UNITED STATES PATENT AND TRADEMARK OFFICE

APPLICATION NO.	FILING DATE	FIRST NAMED INVENTOR	ATTORNEY DOCKET NO.	CONFIRMATION NO.
10/664,385	09/17/2003	Lewis George Gradon	1171/41403	4417

Office Action Summary	Application No. 10/664,385	Applicant(s) GRADON ET AL.	
	Examiner Amadeus S. Lopez	Art Unit 3743

DETAILED ACTION

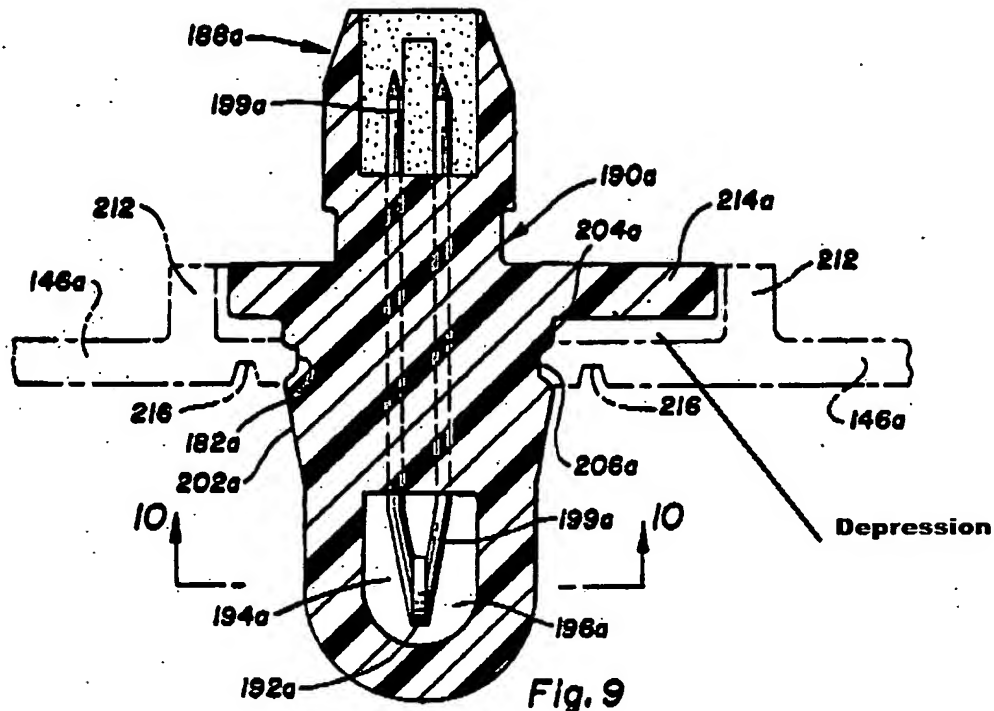
48. Claim 1 is rejected under 35 U.S.C. 102(b) as being anticipated by US Patent No. 5261272 to Rush, II et al. Although the preamble states that the claimed invention is to be used in a breathing circuit, since there is no positive recitation in the claims that ties the component to be used in a breathing circuit, any temperature and flow sensor that would be fully capable of being used in a breathing circuit would reasonably read on the claimed invention.

49. With regards to claim 1, what is taught and shown by Rush, II et al in Fig. 9 shown below is a sensor for an integrated induction system adapted for mounting on an engine to sense temperature and hence flow through the engine. The airflow component has an interior for conveying airflow comprising: a sensor entry port (Fig. 9; gap between base strip 146a) configured to receive a sensor (188a), and a locating depression (labeled below) configured to receive a complementary locating tooth (214a)

from a sensor, the interconnection providing a predetermined orientation of a sensor within said interior.

Fig. 1

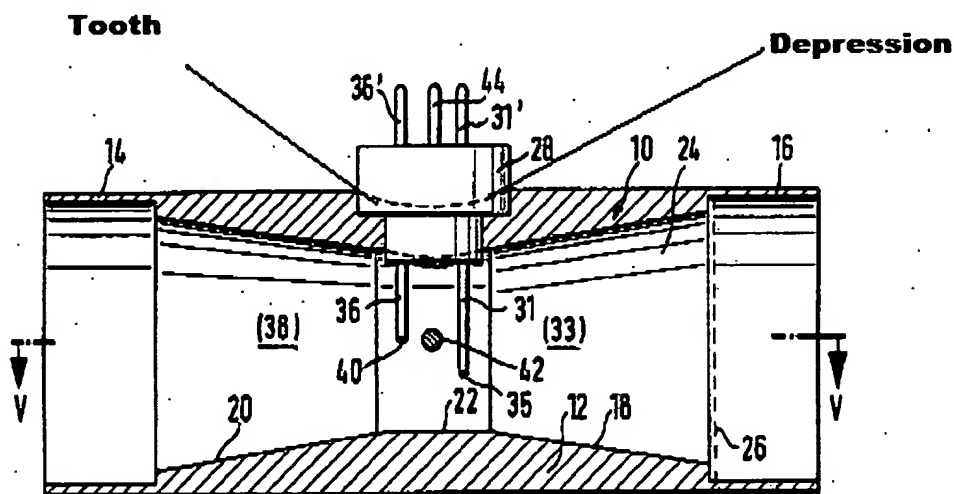
51. With regards to claim 1, what is taught and shown by William in Fig. 1 below is a breathing circuit component or connector having an interior for conveying respiratory gas comprising: a sensor entry port (crossbore passage leading into interior of conduit; Col. 2, lines 61-66) configured to receive a sensor (28; contains sensing elements 34, 35, and 40), and a locating depression (labeled in diagram below as the dotted line portion marking the depression from the outer surface of the conduit) configured to

receive a complementary locating tooth (labeled below; examiner is using a reasonable broad interpretation of the word tooth to be an extension from the body of the sensor which in this case is the larger cylindrical portion of the body of the sensor that fits in the depression) from a sensor, the interconnection of said depression and a tooth providing a predetermined orientation of a sensor within said interior.

52. With regards to claim 14, what is taught and shown by William in Figs. 1-3 is a breathing circuit component having an interior for conveying respiratory gas comprising: a gas inlet (14) communicating with said interior and configured to connect to an outlet of humidifier or other breathing assistance apparatus (respirator; Col. 2, lines 53-55) a gas outlet (16) communicating with said interior and configured to connect to a conduit

(Col. 2, lines 53-55), a sensor entry port (crossbore passage leading into interior of conduit; Col. 2, lines 61-66) configured to receive a sensor (28; contains sensing elements 34, 35, and 40), and a locating depression (labeled in Fig. 1 above as the dotted line portion marking the depression from the outer surface of the conduit) configured to receive a complementary locating tooth (labeled in Fig. 1 above; examiner is using a reasonable broad interpretation of the word tooth to be an extension from the body of the sensor which in this case is the larger cylindrical portion of the body of the sensor that fits in the depression) from a sensor, the interconnection providing a predetermined orientation of a sensor within said interior.

54. **With regards to claim 16**, what is taught and shown by William in Figs. 1-3 is a breathing circuit component wherein said locating depression comprises a notch (labeled in Fig. 1 above as the dotted line portion marking the depression or notch from the outer surface of the conduit) in the end of said cylinder distant said interior.

56. With regards to claim 17, what is taught and shown by William in Fig. 1-3 is a breathing circuit component with all the limitations of claim 16 as rejected above and 17 with the exception of the notch being substantially "V" shaped. What is taught and shown by William in Fig. 1 is a depression that is substantially "U" shaped. After reviewing the specification, the examiner has concluded that at no point in the disclosure does the applicant establish any criticality for utilizing a "V" shaped notch. Therefore it would have been an obvious matter of design choice to one of ordinary skill

58. **With regards to claim 19**, what is taught and shown by William in Fig. 1-3 is a breathing circuit component wherein a diameter of said passage ensures a substantially airtight seal against a sensor located therein (From Fig. 1 it is shown by William that the sensor body completely occludes the passage formed by the crossbore leading into the hollow conduit.
